# SAFETY ALERT

Subject: TPP SW-3 Navaid information missing for Missed Approach Procedure instructions  
on ILS Y RWY 16R, AMDT 6, for Van Nuys (VNY), Van Nuys, CA

# ILS Y RWY 16R

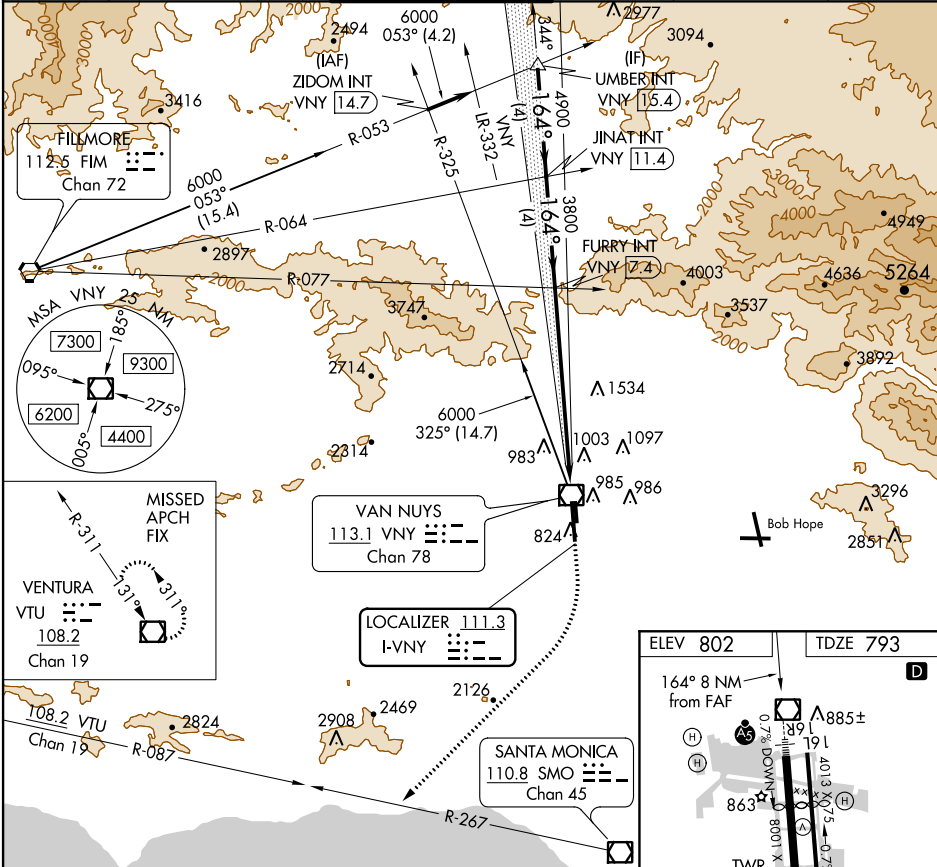
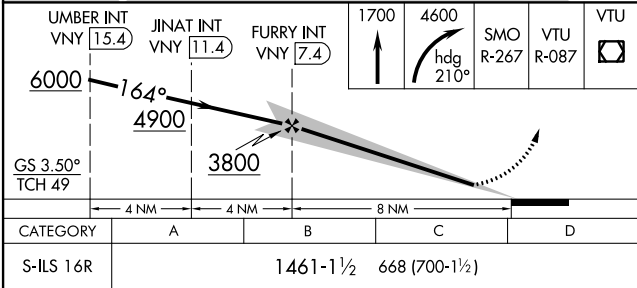
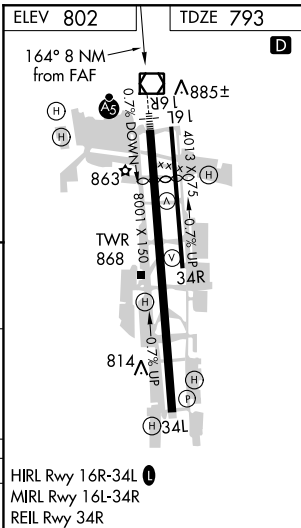
In the Terminal Procedure Publication, SW-3 volume, and the digital-Terminal Procedures Publication, effective July 21, 2016, for Van Nuys (VNY), Van Nuys, CA, ILS Y RWY 16R, AMDT 6, there is a missing Navaid, and its related data to be used for Missed Approach Procedure instructions. The corrected chart will be published on Aug 18, 2016.

Attached is the correct file for the SW-3 volume ILS Y RWY 16R, AMDT 6, for Van Nuys (VNY), Van Nuys, CA.

MISSED APPROACH: Climb to 1700 then climbing right turn to 4600 on heading 210° and on SMO VOR/DME R-267 and on VTU VOR/DME R-087 to VTU VOR/DME and hold.
